TECHNICAL SERVICE BULLETIN

ISSUE DATE:	6/21/2022
SERVICE BULLETIN SUBJECT:	Upper Stanchion Spatula Retrofit
VINs or MODELS AFFECTED:	Service Specified Buses
COMPLETE BY:	Next Service Opportunity
SERVICE BULLETIN #:	SC-22-73
LABOR OPERATION CODE:	IR56Z

UPPER STANCHION SPATULA RETROFIT

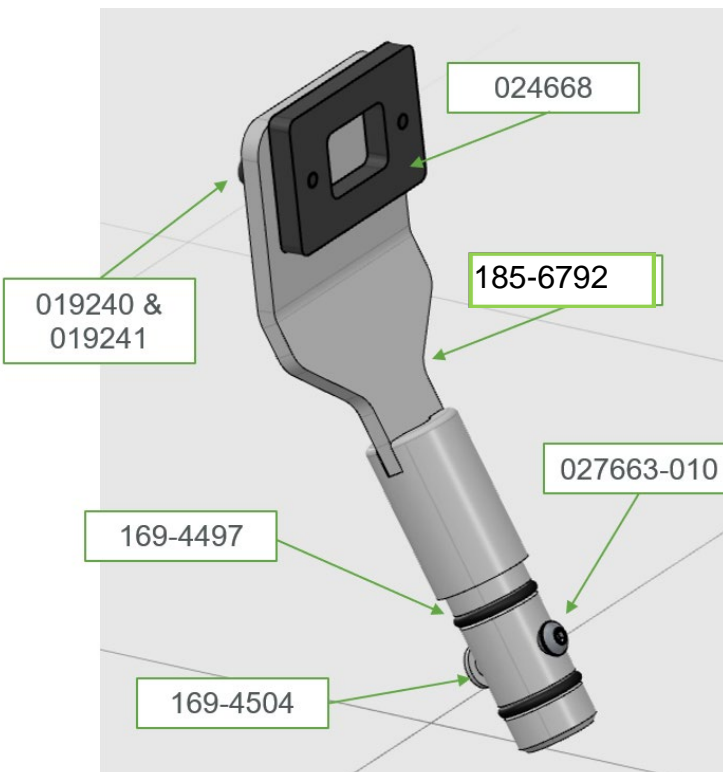
This procedure describes the process of updating the Upper Stanchion Spatula to a more robust version. Multiple Kits (**061154**) will be shipped based on individual customer needs.

1. Working inside the bus, locate any damaged upper Stanchion Fittings.
2. Using a 3/16-Inch Allen Driver, replace the commonly failed Spatulas shown circled in red in the following illustration. Escalate the work order with Proterra Service if additional damaged fittings are found.

3. Using a 3/16-Inch Allen Ratchet/Socket, install the parts from the Kit **(061154)** as shown in the following illustration. Apply Loctite 248 to each threaded fastener as they are installed.

4. Using a Calibrated Torque Wrench with a 3/16-inch Allen Socket, **torque the screws to 88.5 inch-pounds.**
5. Using a UV Torque Marker, mark the properly torqued fasteners.
6. Repeat the process to repair any additional damaged upper Stanchion Fittings.
7. Return the bus to service.
